## Proposal for amendments to Regulation No.79 (Steering equipment)

The text reproduced below was prepared by the experts from Germany and the Republic of Korea with the aim to solve measurement problems regarding the test requirements for ACSF of Category B1 and C.

Figure “Lateral Acceleration Filtering”: Comparison between raw data, filtered raw data according to UN R13H and filtered raw data according to proposed filter design.

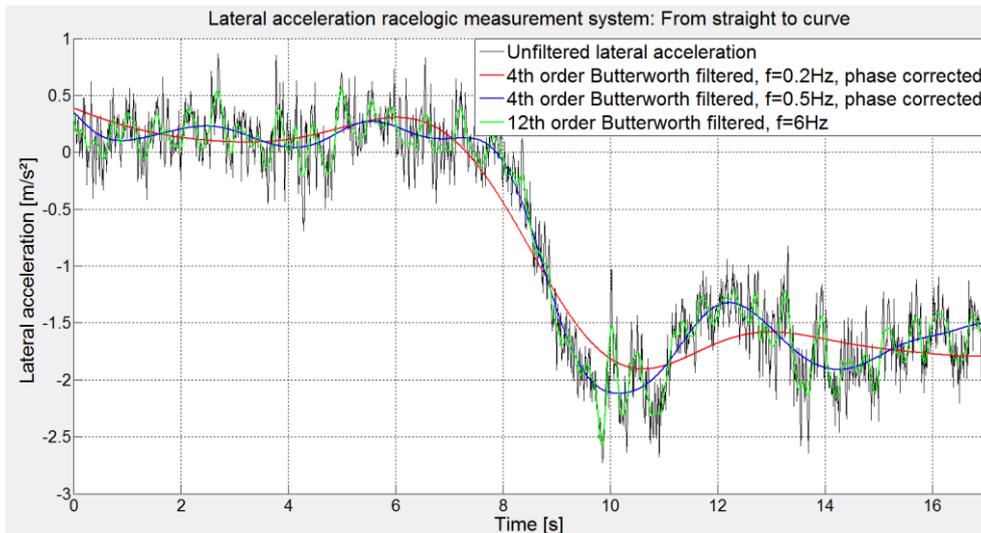
### Annex 8: 2.4. Lateral acceleration

The sample rate and the filtering of the lateral acceleration data should be precisely defined:

- Minimum sample rate of 40 Hz recommended.
- 4th order Butterworth filter with a cut-off frequency of 0.2 Hz recommended.

Proposed filter is designed to ensure that:

- Noise effects are cancelled.
- A stable signal is generated which can be used for a robust evaluation.
- The intention of the lateral control requirements is reflected, i.e., clear system limitations, no lane crossing and no harsh interventions.

**The lateral acceleration and the lateral jerk at vehicle's center of gravity shall be determined. The raw lateral acceleration data shall be measured close to the position of the vehicle's center of gravity. The sampling rate shall be at least 40Hz.**

**To determine the lateral acceleration, the raw data shall be filtered by applying a 4<sup>th</sup> order Butterworth filter with a cut-off frequency of 0.2 Hz.**

**To determine the lateral jerk, the 500 ms moving average of the time derivation of the filtered lateral acceleration shall be considered.**

**The lateral acceleration data at the vehicle center of gravity shall be determined by removing additional effects due to the movements of the vehicle body (e.g. roll of sprung mass) and by correcting for sensor placement via the use of coordinate transformation. As reference, the vehicle coordinate system as described in ISO 8855:2011 shall be used.”**

Figure “Transient Effect”: Filtered lateral acceleration for driving hands off from a straight road into a curve.

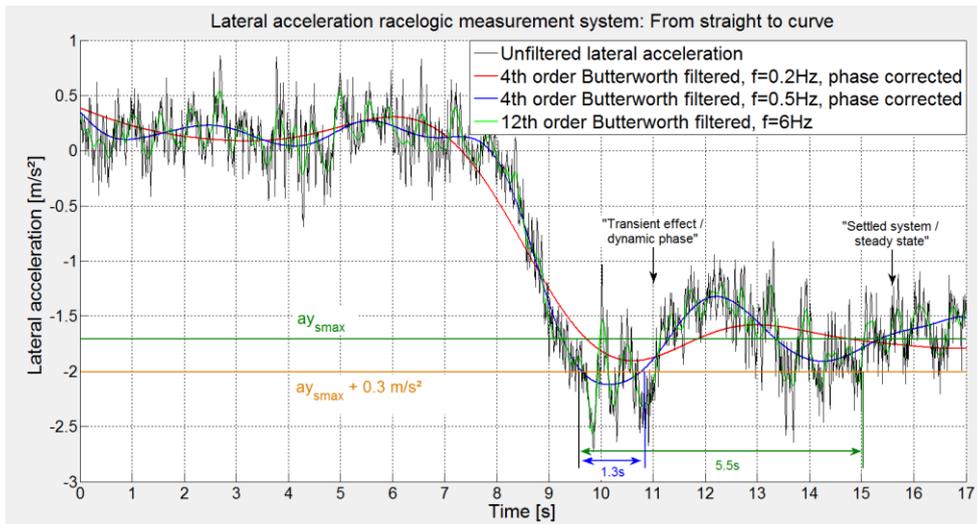
Annex 8: 3.2.1.2.

§5.6.2.1.1.: “(...) The system may exceed the specified value  $a_{y_{max}}$  by not more than  $0.3m/s^2$ , (...)”

This section of §5.6.2.1.1. is not covered by any test case.

**The system does not exceed the specified value  $a_{y_{\max}}$  specified according to 5.6.2.1.1 of this Regulation by more than 0.3 m/s<sup>2</sup>.**
